Licence Number L7798/1993/6

Licensee Deflector Mining Limited

Premises Gullewa Gold-Copper Operations
Mining Tenements M59/49, L59/49, L59/64, M59/68,
M59/356, M59/391, M59/392, M59/335, M59/442
L59/35, M59/507, M59/336, M59/522 and L59/71
Morawa - Yalgoo Road

Amendment

Premises map

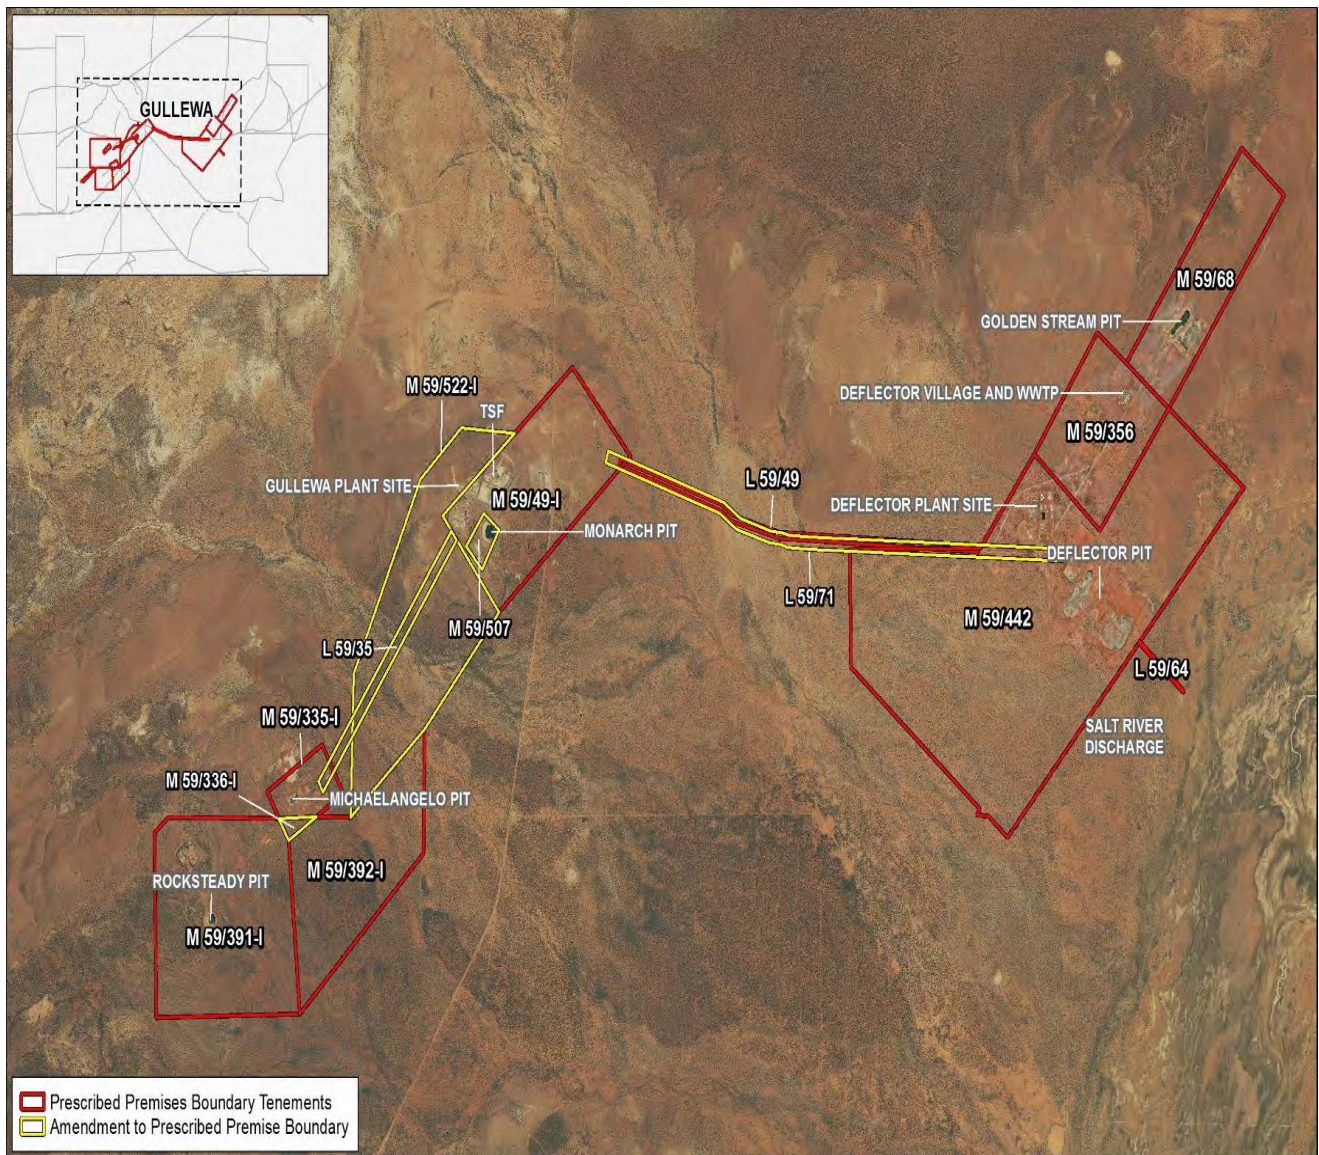
9. The Licence is amended by removing the map in Schedule 1 Premises map and insertion of the map below:

Landfill Area Map

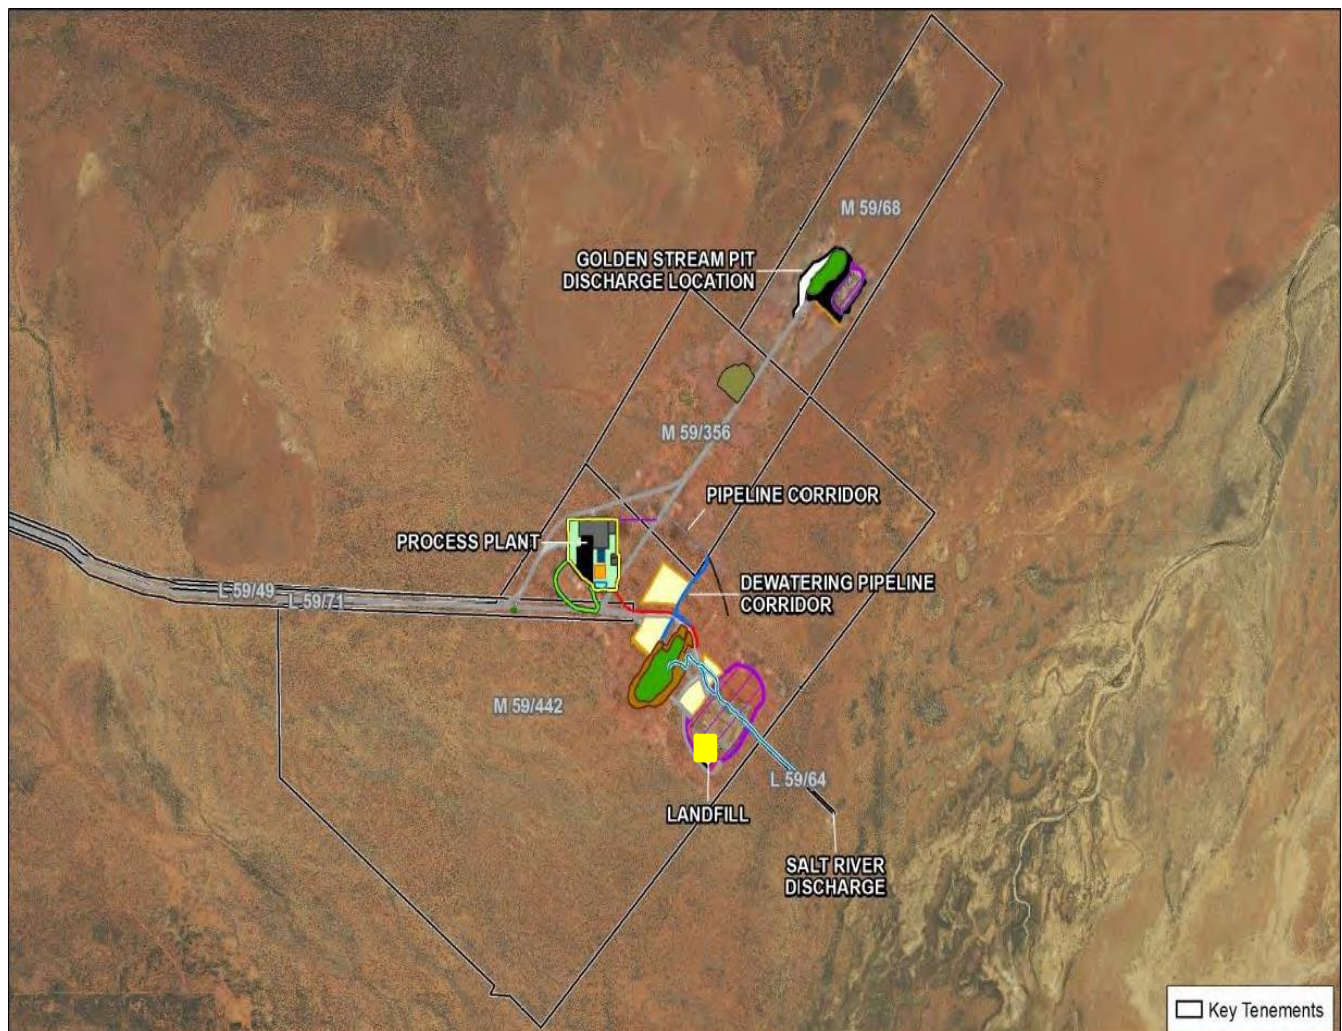
10. The Licence is amended by insertion of the maps below into Schedule 1:
